RS-13-194

Braidwood Station, Units 1 and 2
Facility Operating License Nos. NPF-72 and NPF-77
NRC Docket Nos. STN 50-456 and STN 50-457

Subject: Response to Request for Additional Information - Overall Integrated Plan in Response to Commission Order Modifying License Requirements for Reliable Spent Fuel Pool Instrumentation (Order No. EA-12-051)

**Overall Integrated Plan in Response to Commission Order Modifying
License Requirements for Reliable Spent Fuel Pool Instrumentation
(Order No. EA-12-051)**

ATTACHMENT 1 Braidwood Spent Fuel Pool Elevation Sketch

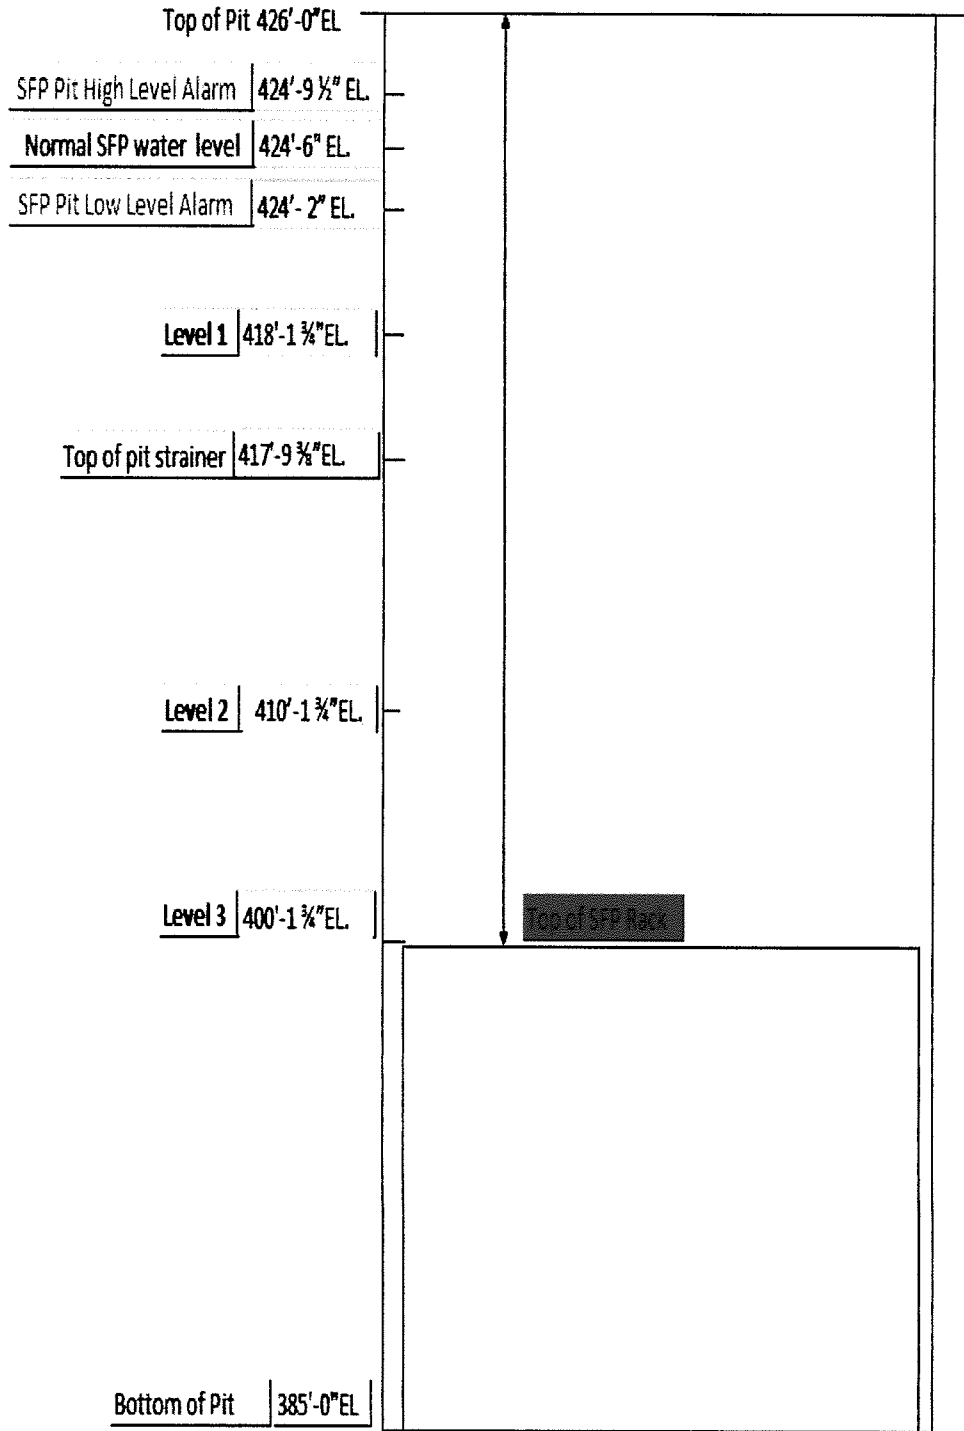
- a) For Level 1, specify how the identified location represents the higher of the two points described in the NEI 12-02 guidance for this level.
- b) A clearly labeled sketch depicting the elevation view of the proposed typical mounting arrangement for the portions of the instrument channel consisting of permanent measurement channel equipment (e.g., fixed level sensors and/or stilling wells, and mounting brackets). Indicate on this sketch the datum values representing Level 1, Level 2, and Level 3 as well as the top of the fuel. Indicate on this sketch the portion of the level sensor measurement range that is sensitive to measurement of the fuel pool level, with respect to the Level 1, Level 2, and Level 3 datum points.

- a) The Braidwood Spent Fuel Pool has two Spent Fuel Pool Cooling Pumps that take suction from the pool with the top of the suction strainer at the 417'-9-3/8" elevation. Normal Spent Fuel Pool Level is at the 424'-6" and low level at 424'-2". The detailed design will include a calculation to determine adequate water level to maintain normal fuel pool cooling system operation. This information will be available following acceptance of the 100% design, scheduled for April, 2014. The result will be provided in the August 2014, 6-month Integrated Plan update report to the NRC.
- b) A sketch is provided as Attachment 1, "Braidwood Spent Fuel Pool Elevation Sketch". Instrument probe mounting details in the Spent Fuel Pool area will be provided in accordance with our response to RAI-3.
